SERVICE BULLETIN

MW-5 Transmitter

Bulletin No. AM-107-EEB**Date** 2/7/77

FIGURE 8-2. MW-5A TRANSMITTER, OVERALL SCHEMATIC 852 7591 002

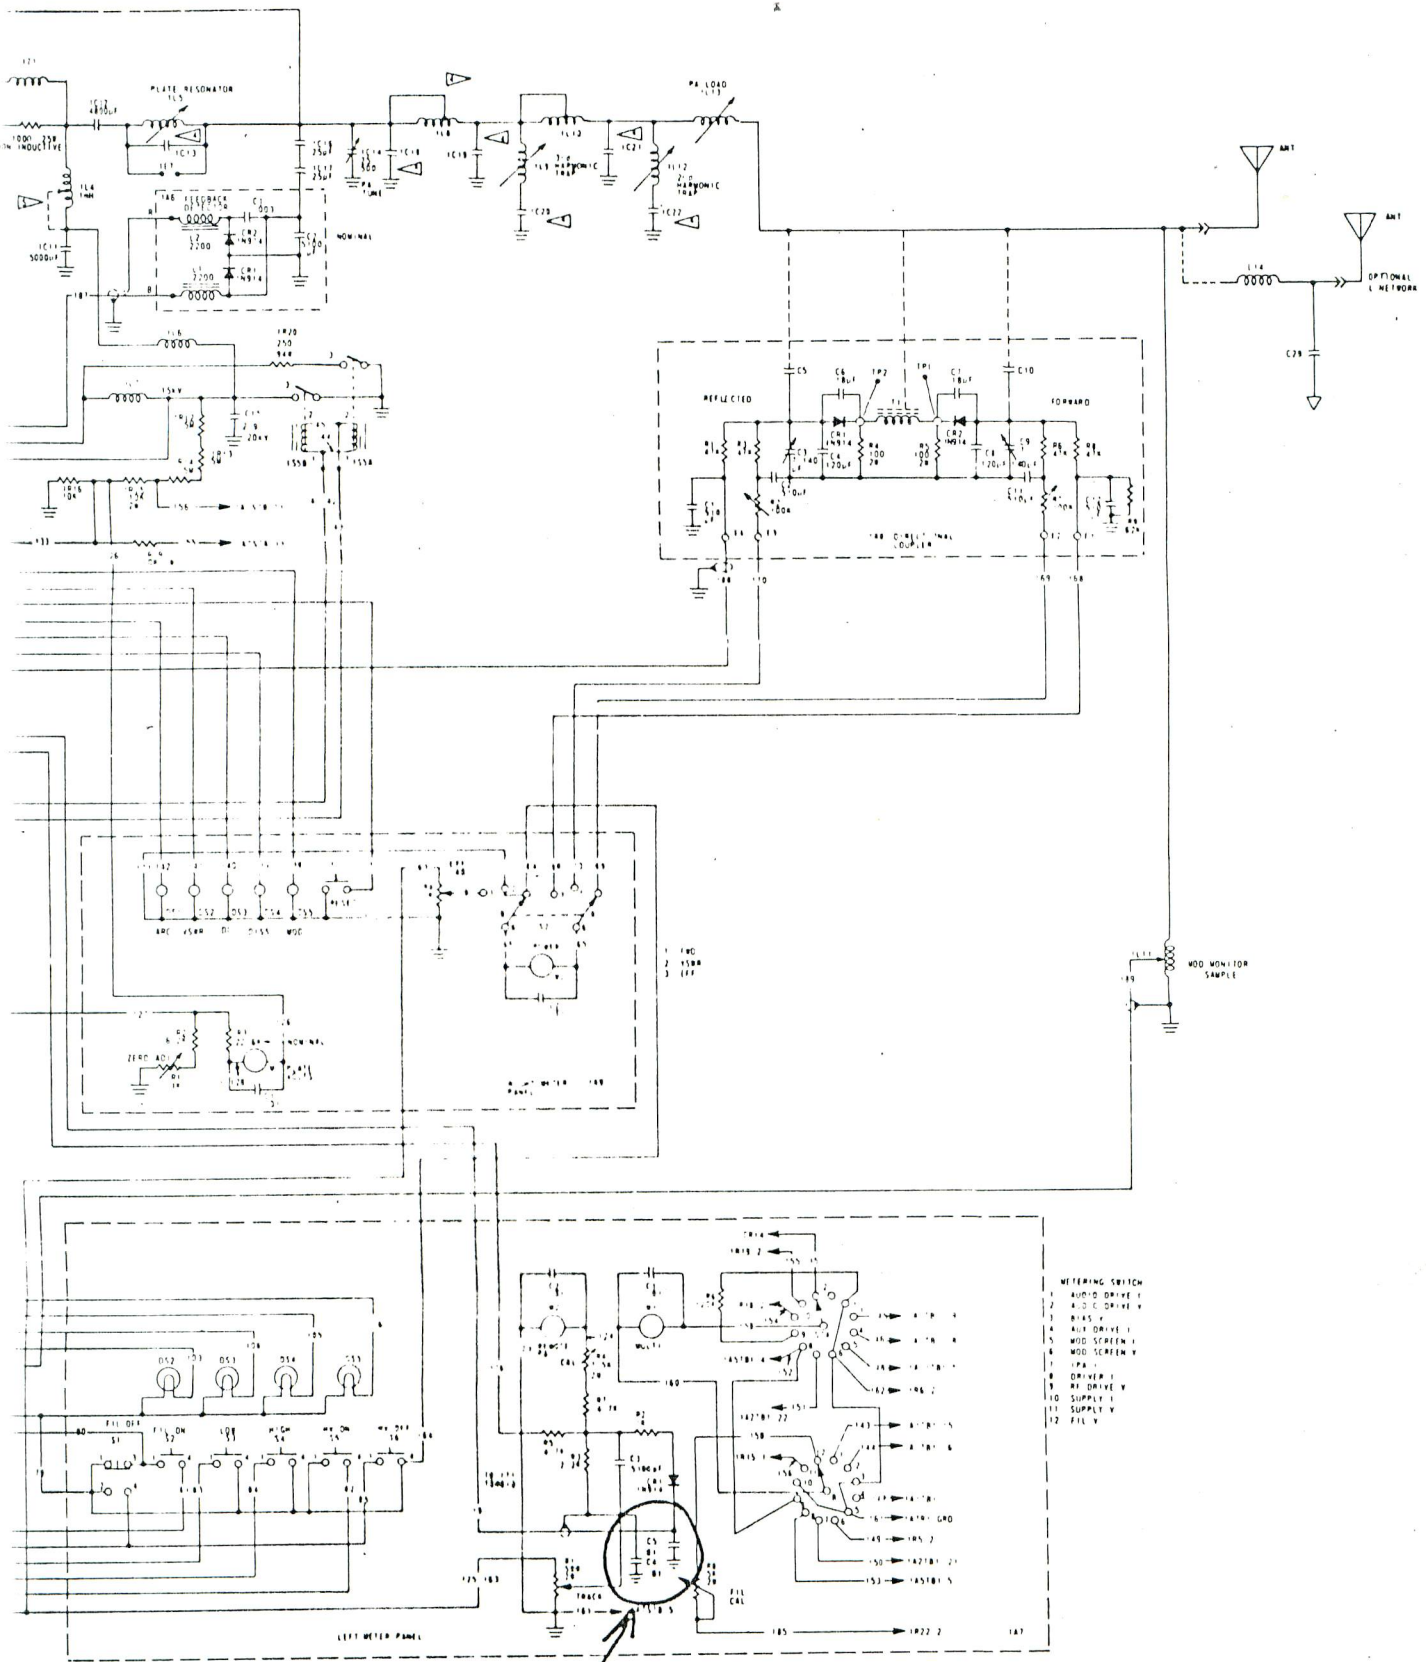
To improve the output linearity and tracking of this circuit add two $\frac{1}{4}$ watt, 1 megohm resistor, Harris part number 540-0984-000. These resistors are to be connected from pins 11 and 12 to pin 14 of U-1 on the Flag and Overload Assembly, Board 1A2A2 as shown on the attached drawing. Readjustment of R-22 on the flag and overload assembly and the remote control system pot for proper balance as the transmitter is cycled between low and high power, will be necessary.

To make the meter less susceptible to high modulation peaks add two .01 mfd. 1000 volt capacitors, Harris part number 516-0082-000, as shown on the attached drawing. Readjustment of the tracking and calibration controls (1A7R1 and 1A7R4) are necessary.

*SECTION 3
ADDITIONAL
.01 MFD
CAPACITORS*
